Access Compliance Report

Public Rights-of-Way

Intersection ID: 45981	Main Street: LAUREL_VALLEY_RD	Cross Street: MASON_MILL_PL	Location: NE
ADA ID: 5D26966E6FA3	Ramp Type: PerpDiag	Initial Pass/Fail: Fail	Overall Compliance: No
Severity Score: 8.75			
Codes/Mitigation Info/Possible Solution		Field Measurements/Component Compliance

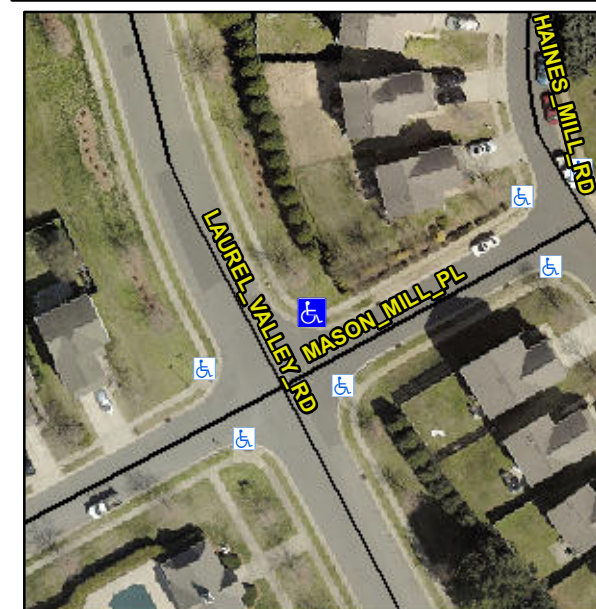
Not Found, R304.5.1

Compliance	Description	Data	Compliance	Description	Data
N/A	Ramp Length (in)	48.0	Yes	Ramp Slope (%)	5.4
No	Ramp Width (in)	47.0	Yes	Ramp XSlope (%)	1.9
N/A	Flare Type LT	N/A	N/A	Flare Type RT	N/A
N/A	Flare Slope LT (%)	N/A	N/A	Flare Slope RT (%)	N/A
N/A	Flare Traversable LT?	N/A	N/A	Flare Traversable RT?	N/A
N/A	Landing Length (in)	N/A	N/A	DWS Provided?	N/A
N/A	Landing Width (in)	N/A	N/A	DWS Contrast?	N/A
N/A	Landing Slope (%)	N/A	N/A	DWS Length (in)	N/A
N/A	Landing X Slope (%)	N/A	N/A	DWS Full Width?	N/A
N/A	Landing Curb? (Y/N)	N/A	N/A	DWS Offset (in)	N/A
N/A	Shared Landing?	N/A			
N/A	Gutter Ponding?	N/A	N/A	Gutter Slope (%)	N/A
N/A	Gutter Lip Ht (in)	N/A	N/A	Gutter X Slope (%)	N/A
N/A	Painted X Walk1?	No	N/A	Painted X Walk2?	No
	X Walk 1 Direction	To W		X Walk 2 Direction	To S
N/A	X Walk 1 Width (in)	N/A	N/A	X Walk 2 Width (in)	N/A
	X Walk 1 Slope (%)	1.4		X Walk 2 Slope (%)	1.6
	X Walk 1 X Slope (%)	1.1		X Walk 2 X Slope (%)	2.4

Remove & Replace Curb Ramp With Two New Directional Ramps or Equivalent.
